REQUEST FOR COUNCIL ACTION

AGENDA SECTION:	ORIGINATING DEPT:	ITEM NO.
PUBLIC HEARINGS	PLANNING	E-5
ITEM DESCRIPTION: Type III, Phase III Incentive Developm St. Pius X to permit additions to the existing facility that would ratio in the zoning district. The property is bounded by 14 th St NW on the west, 12 th Street NW on the south and 12 th Avenu	PREPARED BY: Theresa Fogarty, Planner

Type III, Phase III Incentive Development Final Plan #02-50 by

Church of St. Pius X to permit additions to the existing facility that would exceed the permitted floor area ratio in the zoning district. The property is bounded by 14th Street NW on the north, 13th Avenue NW on the west, 12th Street NW on the south and 12th

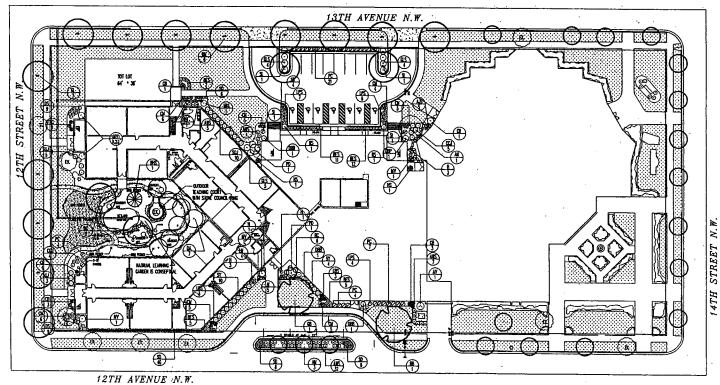
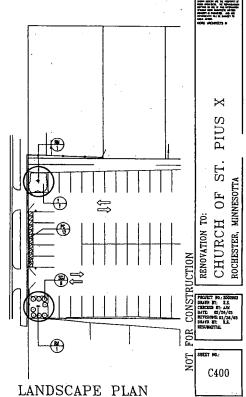
The landscaping plan for the church property provides an abundant amount of landscaping for the property. The parking lot located north of 14th Street NW will be striped to accommodate 87 vehicles. Landscaping will be provided along 14th Street NW in this parking lot.

- e) Foundation and Site Plantings: A landscape plan for the site has been prepared which indicates the finished site will be consistent with the landscape character of the surrounding area.

- g) Screening and Bufferyards: According to the landscaping plan provided there will be an abundant amount of landscaping on the property. There will be more landscaping then what currently exists on the property.

PHASING DIAGRAM

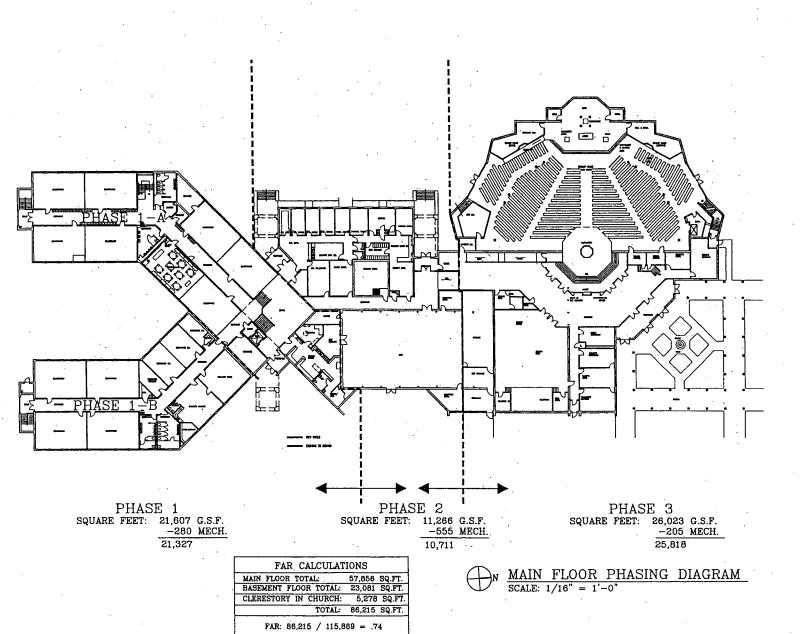
The applicant has submitted an application of an Incentive Development final plan on only a portion of the project that was approved in the preliminary plan. The renovations to the property have been divided into 3 phases. Phase I is the school renovation and addition, Phase II the renovations and addition to the church administration offices and Phase III is the renovation and

addition to the sanctuary. The applicant is only asking for approval of Phase I and II. Phase III will need to be applied for at a later date.

A major difference in building elevations in the final plan from the preliminary plan is that the rotunda over the gym has been removed. Another difference is that the floor area ratio calculation for all three phases is .74. The variance granted by the Commission was only for a FAR of .71. At the time the application is submitted for phase III the overall FAR will need to be .71 or another variance will need to be applied for.
